Subject: Re: Edison Way Project

To: Michael Lam Subject: Re: 115 Edison Way

Public comments for my 10/17 ZA item 241362.

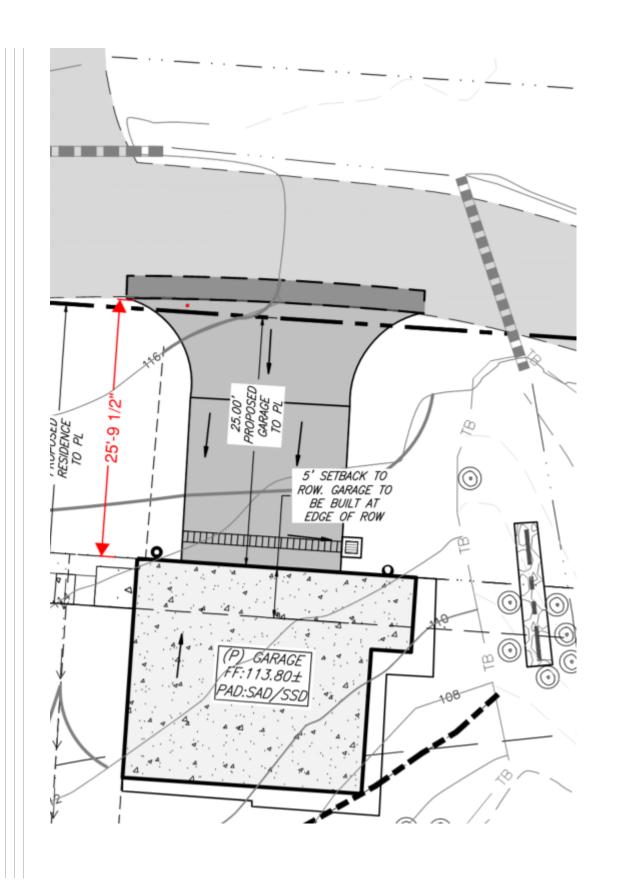
The garage needs to be 20 feet back from the edge of the right of way so that they can park cars out of the right of way and or pay to widen the road before and after that parcel to eliminate the need for emergency vehicles to use that space.

The submitted drawing is unclear, and I need clarification on one point immediately: what does "PL" stand for? From the looks of the plans it is right next to the right or way not 25 feet back from it.

More critically, I must state in the strongest possible terms that any plan that sets the stage where the new owners lwll encroach upon any portion of the existing right-of-way for vehicular or material storage is unacceptable. That right-of-way is the only path that allows emergency vehicles to reach the property beyond. Blocking, narrowing, or repurposing that area such that it becomes used for private use creates an obstruction that directly threatens fire access, public safety, and my own personal safety.

Please confirm receipt of this objection, explain the "PL" notation, and provide a revised plan that clearly preserves the full width and function of the right-of-way for emergency passage.

On Thu, Oct 16, 2025 at 10:57 AM Chelsea Mele <<u>chelseamele@gmail.com</u>> wrote:
That is not acceptable as there cars will block the fire escape route. That is the only place you can get past a fire truck! And you and I both know they will be parking cars in front of the garage

The road is not paved to the full width of the right-of-way; there is 25-feet of area between the paved road and the proposed garage (see snip below). The proposed garage will be located at *edge* of the right-of-way boundaries – this means that, in the future, the road can be potentially widened to the edge of the right-of-way.
